**SUBJECT:** Contract No. DE-AC24-03OH20152: Deliverable #39 Potential release site and removal action documentation; Section C.2.3.1.3 Remaining Response Actions; PRS 11 PRS Package Addendum 1, Final

# Miamisburg Closure Project Potential Release Site Package PRS 11 Addendum 1

# Response to Public Comments

From MMCIC  
on PRS 11 Data Package and Fact Sheet  
February, 2005

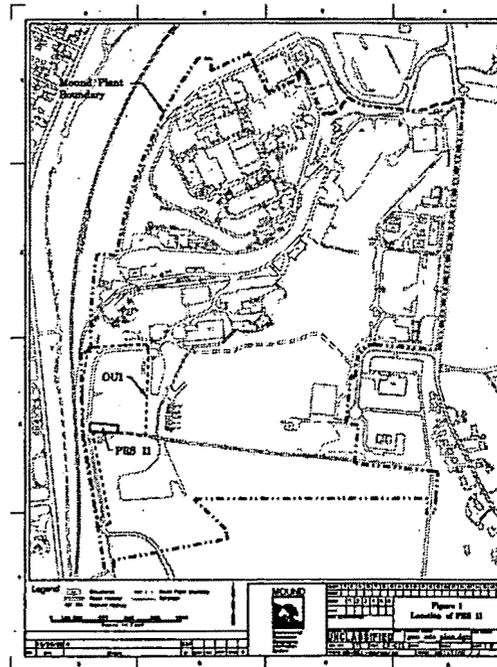
The exact location and boundaries of PRS 11 are uncertain. The uncertainties of the boundaries of the contamination of PRS 11 & the associated buried remains of the Dayton Unit Fire should be reflected in both the text and Figure 1 of the Public Fact Sheet.

There is no documentation of the total extent of where the regraded materials were placed, and therefore the exact locations of the boundaries of PRS 11 cannot currently be defined. Regrading is an inherently crude activity. It is reasonable to expect that radioactive contaminants at PRS 11 have a wider dispersal area than is currently defined in PRS 11 Public Fact Sheet text and Figure 1.

PRS 11 Public Fact Sheet Figure 1 shows boundaries for PRS 11 that miss much of the area where the historic remains of the Dayton Unit are indicated to be on Figure 2.7 in the History of Area B (February 1991). Figure 2.7 is attached as Attachment #1.

**Response 1.** Geophysical characterization as well as radionuclide assessment via gamma-ray spectroscopy on soils from well installation for the Air Sparge and Soil Vapor Extraction systems has provided more information regarding the thorium drum disposal area. A refined picture can be found in attached Figure 1 and the sample results are contained in Mound Environmental Information Management System (MEIMS) database. Also, recent additional geophysical characterization activities, utilizing the best technologies available, were performed to further define the location of the buried thorium contaminated drums.

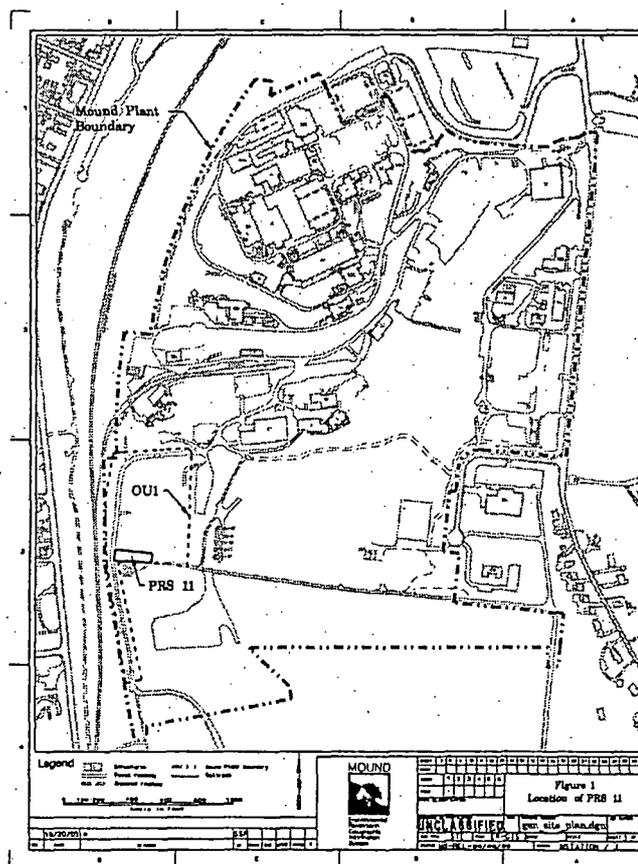
**Comment 1.** PRS 11 addresses the removal of buried thorium contaminated drums. During installation of drainage features for OU-1, fragments of thorium contaminated drums were actually found. The same magnetic survey that showed the PRS 11 thorium drums also indicated another possible location of buried drums known as "B3". Since there is no evidence to prove that B3 is not thorium contaminated drums, it would seem logical to investigate the B3 magnetic anomaly during the PRS 11 excavation and removal. Will the PRS 11 Removal Action address B3 in any way? If not, how will B3 be characterized and removed if necessary?

**Response 1.** During the Air Sparge and Soil Vapor Extraction systems installation wells AS-N17 and AS-N18 did not indicate the presence of thorium 232 above cleanup objectives. See Figure 1 for a graphical depiction. Recently additional geophysical characterization activities, utilizing the best technologies available, were performed to further define the location of the buried thorium contaminated drums. This latest characterization confirmed the presence of ferrous debris at the B3 location (AS-N18). However, no radioactivity associated with the thorium contaminated drums was detected during the gamma logging of AS-N18. Should the excavation for the buried contaminated drums extend into the B3 anomaly, provisions are in the approved Work Plan for addressing it.
